Access Compliance Report

Public Rights-of-Way

Intersection ID: 51470	Main Street: HUCKS_LANDING_DR	Cross Street: HUCKS_RD	Location: E
ADA ID: 3057F7A93065	Ramp Type: BlendTrans1	Initial Pass/Fail: Pass	Overall Compliance: No
Severity Score: 0.25			
Codes/Mitigation Info/Possible Solution		Field Measurements/Component Compliance

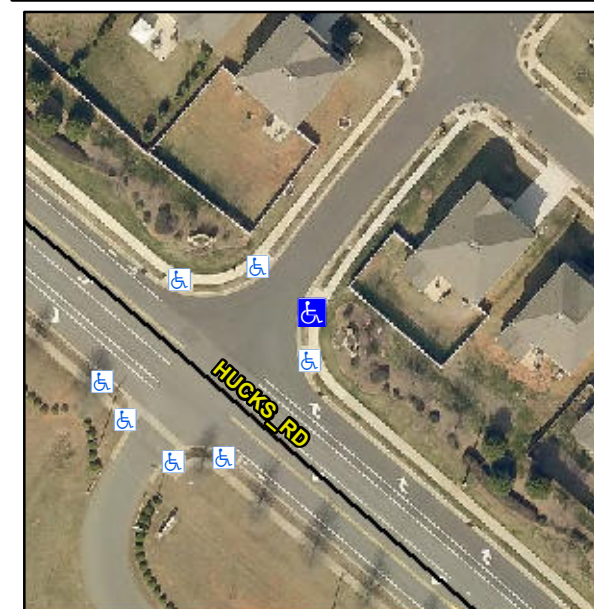
Not Found, R304.5.3, R305.2

Compliance	Description	Data	Compliance	Description	Data
N/A	Ramp Length (in)	53.0	Yes	BlendTrans Slope (%)	3.9
Yes	Ramp Width (in)	48.0	No	BlendTrans XSlope (%)	3.3
N/A	Flare Type LT	Sloped	N/A	Flare Type RT	Sloped
Yes	Flare Slope LT (%)	2.3	Yes	Flare Slope RT (%)	7.7
N/A	Flare Traversable LT?	Yes	N/A	Flare Traversable RT?	Yes
Yes	Landing Length (in)	55.0	Yes	DWS Provided?	Yes
Yes	Landing Width (in)	49.0	Yes	DWS Contrast?	Yes
Yes	Landing Slope (%)	1.6	Yes	DWS Length (in)	24.0
Yes	Landing X Slope (%)	2.0	Yes	DWS Full Width?	Yes
N/A	Landing Curb? (Y/N)	No	No	DWS Offset (in)	7.5
N/A	Shared Landing?	No			
Yes	Gutter Ponding?	No	Yes	Gutter Slope (%)	4.3
Yes	Gutter Lip Ht (in)	0.0	No	Gutter X Slope (%)	3.5
N/A	Painted X Walk1?	No	N/A	Painted X Walk2?	N/A
	X Walk 1 Direction	To NW		X Walk 2 Direction	N/A
	X Walk 1 Width (in)	N/A		X Walk 2 Width (in)	N/A
	X Walk 1 Slope (%)	0.6		X Walk 2 Slope (%)	N/A
	X Walk 1 X Slope (%)	3.3		X Walk 2 X Slope (%)	N/A

N/A	Ramp inside XWalk1?	N/A	N/A	Ramp inside XWalk2?	N/A
	Road Slope (%)	3.3		Clear Space?	Yes
	Road X Slope (%)	0.6	N/A	Clear Space to XWalk (in)	N/A
Yes	Any Obstructions?	No	Yes	Storm Grate/Utility Hazard?	No
	Obstruction Type			Storm Grate/Utility Type	
		N/A			N/A
			Yes	Surface Condition? (G/P)	Good
			No	Curb Slope (%)	9.8

Remove & Replace Curb Ramp With Two New Directional Ramps or Equivalent. Remove & Replace Gutter.
